**Submission to the Environmental Protection Agency of the
Northern Territory**

Ammaroo Ammonium Phosphate Fertiliser Project

**Referral for Significant Variation dated 9 November 2022 submitted
by Verdant Minerals Pty Limited**

REVIEW OF AMMAROO PHOSPHATE PROJECT REFERRAL ADVICE

ANNEXURE A - MAP

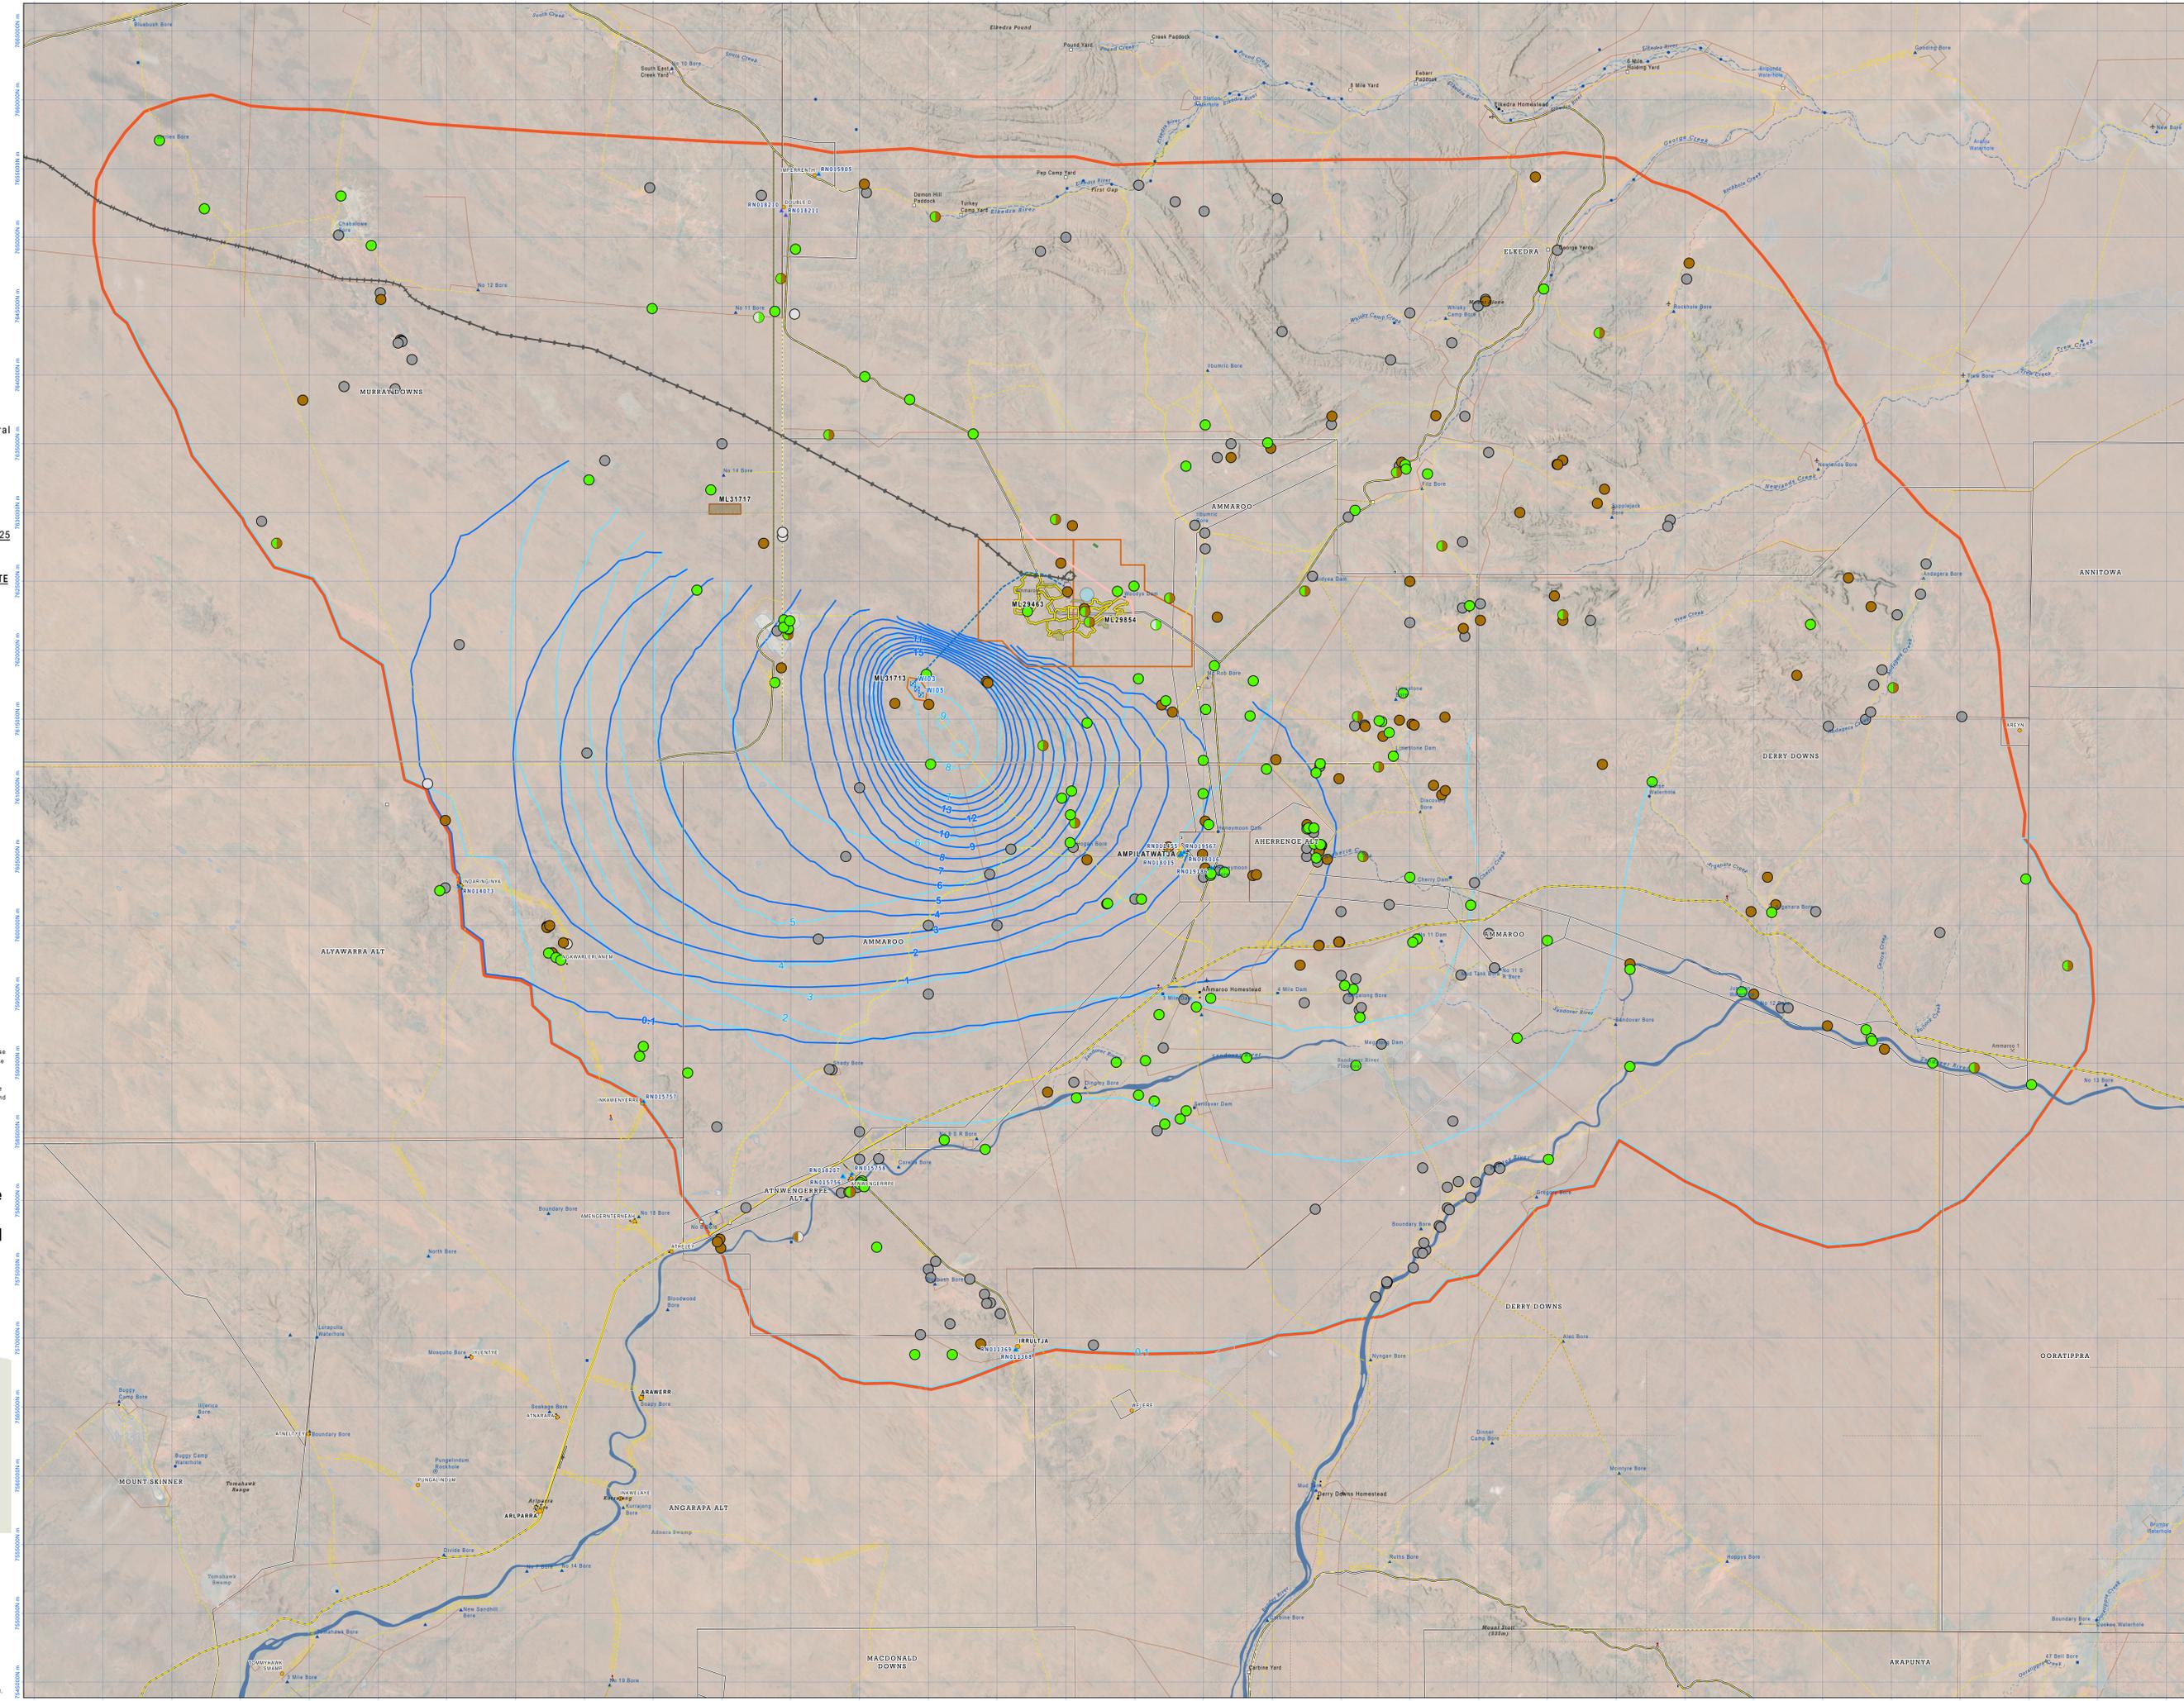
22. There are at least 72 culturally sensitive and groundwater dependent sites within the P90 1m drawdown contour. The potential impacts of the significantly increased groundwater drawdown associated with the project need to be carefully assessed in an EIS. See Annexure B for the map (2022-316d) showing the community bores and sites within the water table drawdown for ML 31713, ML 29463 and ML 29854.
